# la marzocco technical bulletin #149

## New Safety Thermostat E.5.005

January 24, 2019

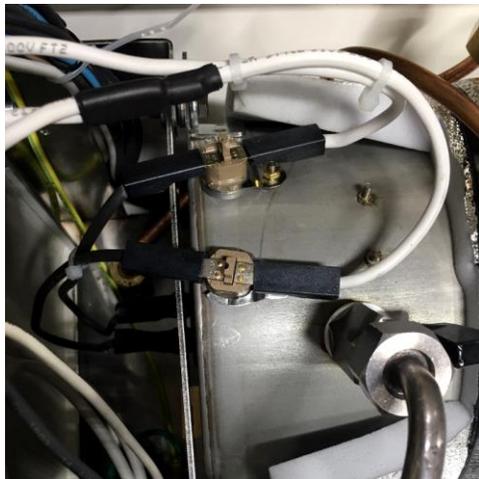
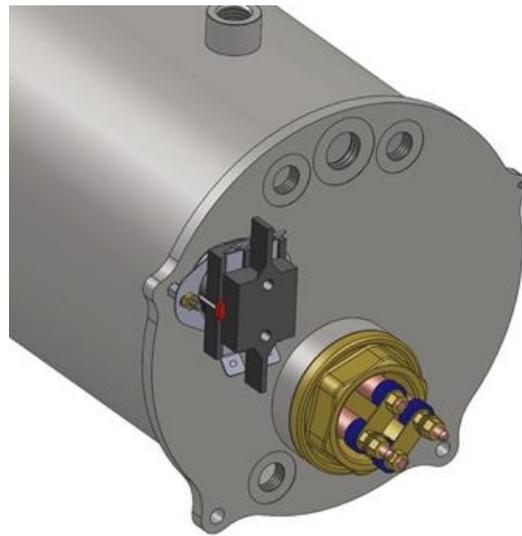
As part of La Marzocco's continuous improvement process and to satisfy the latest certification requirements, we are introducing a new double pole safety thermostat, E.5.005.

Starting with the listed serial numbers, the new safety thermostat is present in the following three and four group machines:
